Supplementary Planning Statement Brockley Hill, Stanmore – New Banqueting Facility

Relating to site at
Former Stanmore and Edgware Golf Centre
January 2021

Figure 1: Site Location Plan with revised site area / planning application boundary

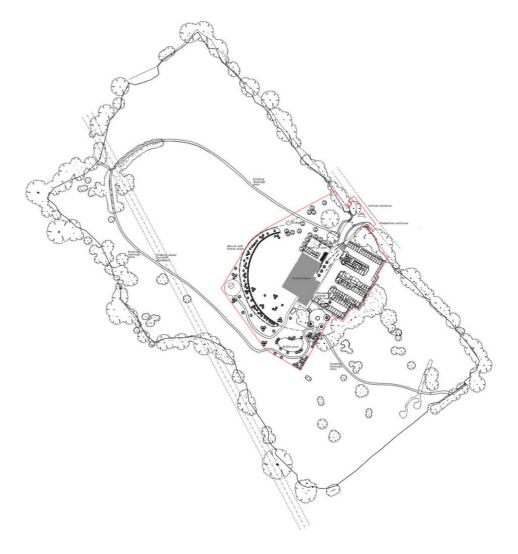
- 1.4 The site area as submitted comprised of land containing the former club housing building, putting green, car park, entrance part of the driving range to the north of the club house. There is now a requirement to amend site area and the revised red line boundary is shown in Figure 1. The planning application site area is 1.63 hectares.

- 1.5 The revised application site area is wholly contained within the original planning application boundary on land owned by the applicant, Sairam Holdings Ltd, and by Sairam (Watford Op) Ltd, being the same ownership / interested parties as advised in the amended application and notices submitted to LBH on 25th September 2020.

Figure 2: Proposed Site Plan (submitted August 2020) (above). Figure 3 (Amended Site Plan) (January 2020) (below)

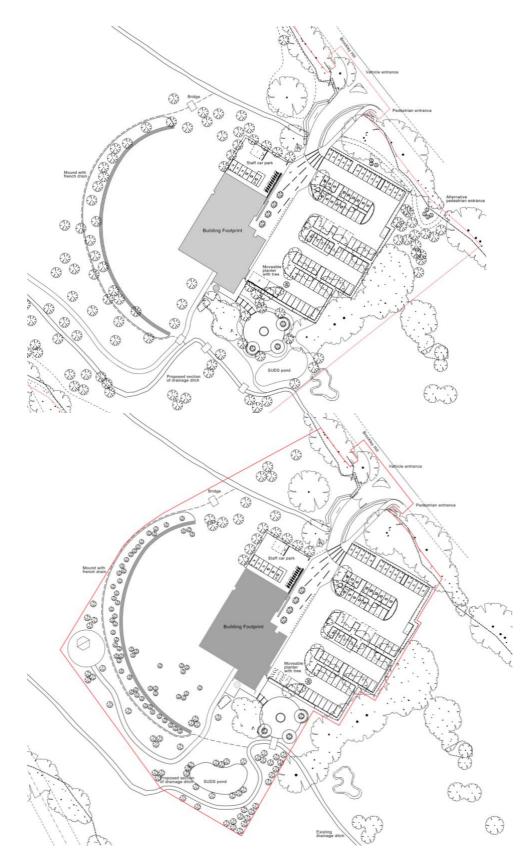
- 2.2 The change in site area has resulted in some minor amendments to scheme. Figure 2 below shows the submitted scheme and Figure 3 the revised scheme. The changes are as follows:

- Re-siting of the SUDS pond. No change in volume.
 - Re-siting of the secret garden.
 - Retention of the willow trees to the south of the secret garden area.

- Revision to the pagoda and path to increase accessibility for guests.
 - Re-routing of drainage ditch to reflect re-sited SUDS pond.
 - 17 short stay cycle parking in the car park.

- Main entrance vehicle gate in response to comments from the Secure by Design Officer.
 - The removal of one small tree in the secret garden area and another small tree adjacent to the secret garden area, both of which are poor Category C trees.
